TE Connectivity

Product Change Notification: PCN-25-237831

250 FASTON POST INS.,REC.,1 POS,NATURAL

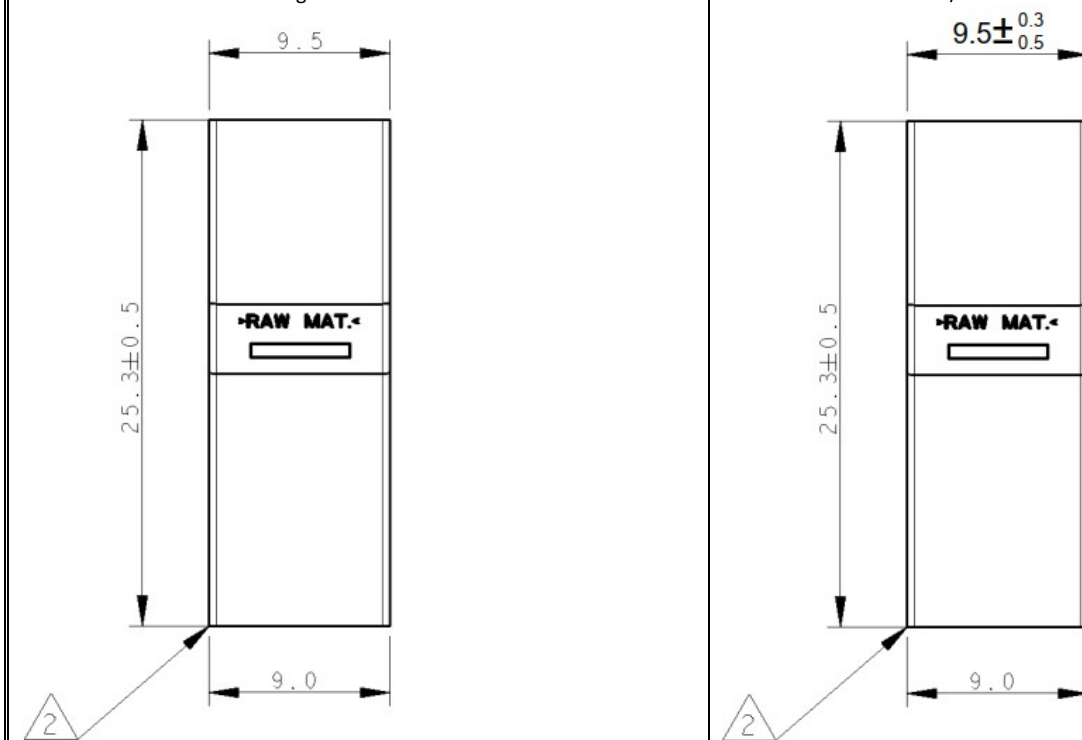
CD Update for tolerance clarification for width dimension 9.5+0.3/-0.5

Dimension was 9.5 before change

Tolerance clarification, no functional impact.
